Summary - Did performance of ST12 SEE System meet criteria for shutdown and transition?

Status of performance criteria for shutdown of ST12 SEE system

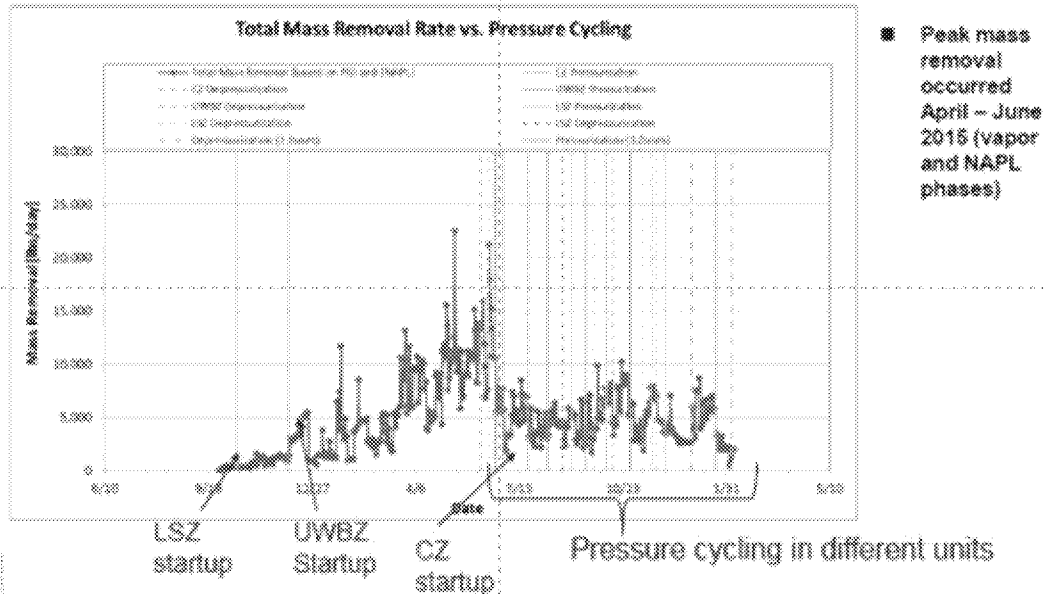
- a) Although Lower saturated zone is achieving the objective as of shutdown of steam injection, Upper Water Bearing Zone and Cobble Zone still have LNAPL present in jar tests and benzene concentrations greater than 2000 ppb within the interior of the thermal treatment area.
- b) Still considerable mobile LNAPL remaining in Cobble Zone interior of the thermal treatment area at the time the extraction system was shut down. There is considerable concern that LNAPL and dissolved BTEX will spread once the water levels recover and there is no hydraulic containment. Benzene concentrations still well over 1000 ppb.

Performance Criterion for residual benzene concentrations has not been met

Extracted Vapor Benzene Concentrations over Time

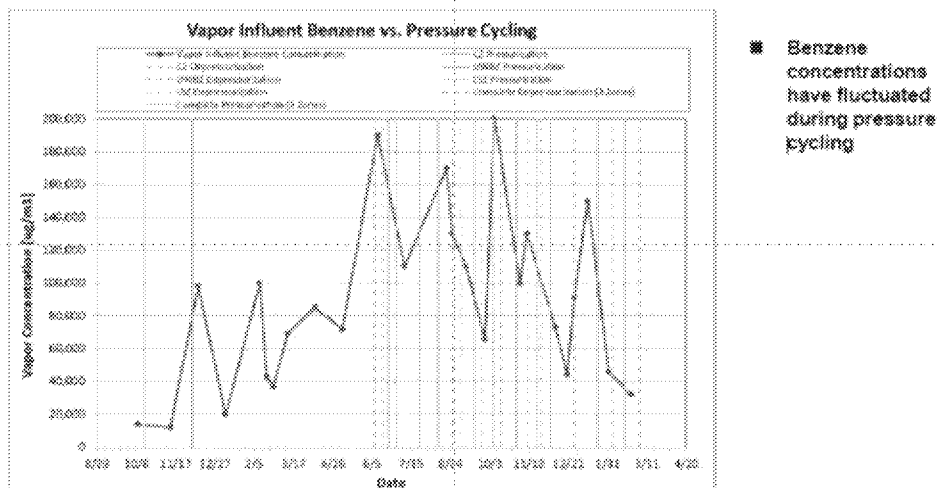
4) Criterion for Pressure Cycling : *“the process is repeated . . .until no additional significant increases in effluent vapor phase concentrations occur when steam pressure is reduced” has not been met, as the figures below indicate that each pressure cycle was still producing significant increases in mass removal. The effectiveness had not diminished.*

Pressure Cycling & Benzene Vapor Mass Removal over time

Extracted Liquid Benzene Concentrations over Time (measured at air stripper influent by EPA Method 8260B)

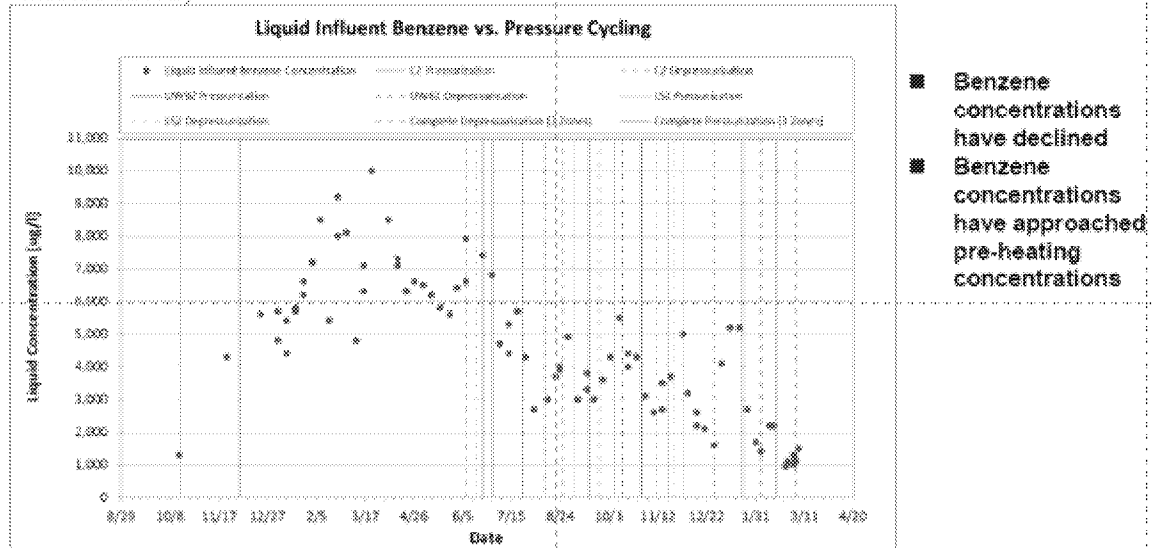
Pressure Cycling & Benzene Liquid Mass Removal

Concentrations of benzene recovered in air stripper effluent were declining but still above 1000 ppb indicating significant recovery still taking place.
